Item Name: Replacement Skidtube

DESIGN		**DART AEROSPACE LTD** HAWKESBURY, ONTARIO, CANADA
DRAWN	RF	
CHECKED		DRAWING NO. D2580 — REV. E — SHEET 1 OF 8
MFG. APPR.		
APPROVED		TITLE: 205 SKIDTUBE ASSEMBLY — SCALE: NTS
DE APPR.		
DATE	11.06.21

DRAWING NO.	TITLE	REV. E	DART AEROSPACE LTD ENGINEERING ORDER	D.E.O. NO.	SHEET NO.	SCALE
D2580	205 SKIDTUBE ASSEMBLY			D2580-E-1	SHEET 1 OF 1	NTS

PURPOSE:
CHANGE ALL C'BORED WELDED CROSSBOLT SPACERS TO SWAGED SPACERS

SECTION B-B D5-2
SCALE 5X

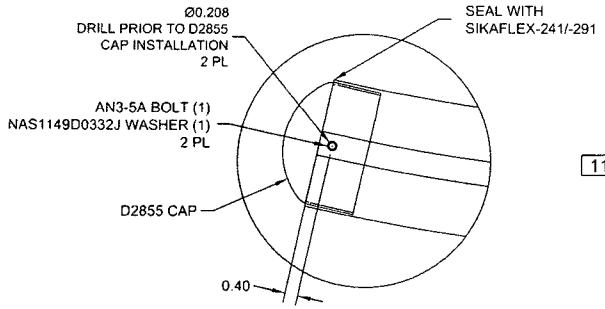
AFTER DRILLING AND BENDING ASSEMBLY
PERFORM THE FOLLOWING FOR Ø0.508 HOLES ONLY:
1. CHAMFER HOLE 0.050 X 45°
2. INSERT D2579 SPACER (20 PLACES)
3. WELD INTO PLACE AND GRIND FLUSH
4. C'BORE D2579 SPACER TO Ø0.437 X 1.00 DEEP

SECTION B-B, F-F, I-I
NOT TO SCALE

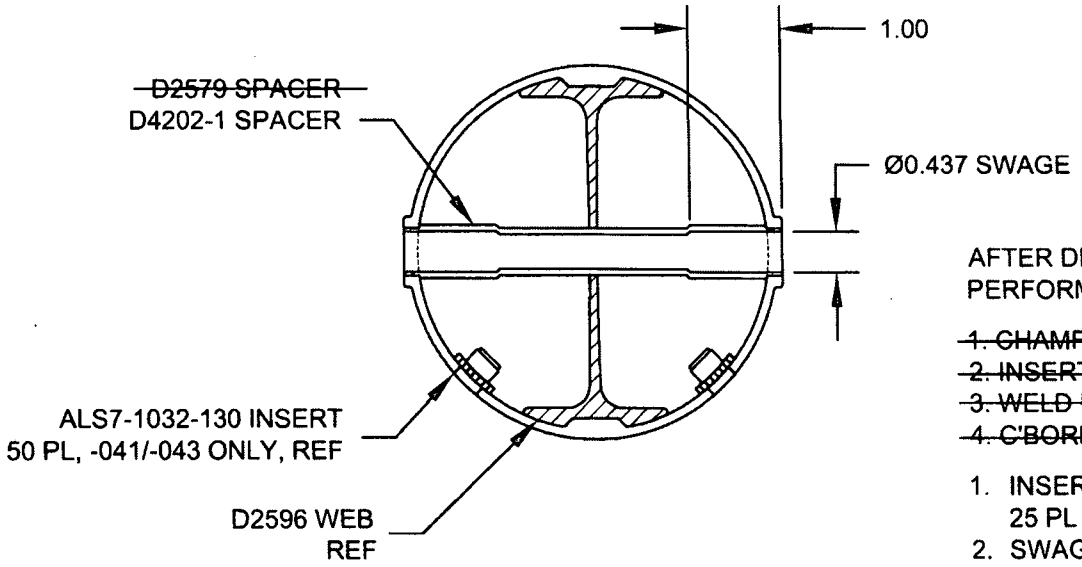
SECTION B-B, SECTION F-F, & SECTION I-I ARE AMENDED AS FOLLOWS
FOR ALL HOLES THAT WERE ORIGINALLY C'BORED:
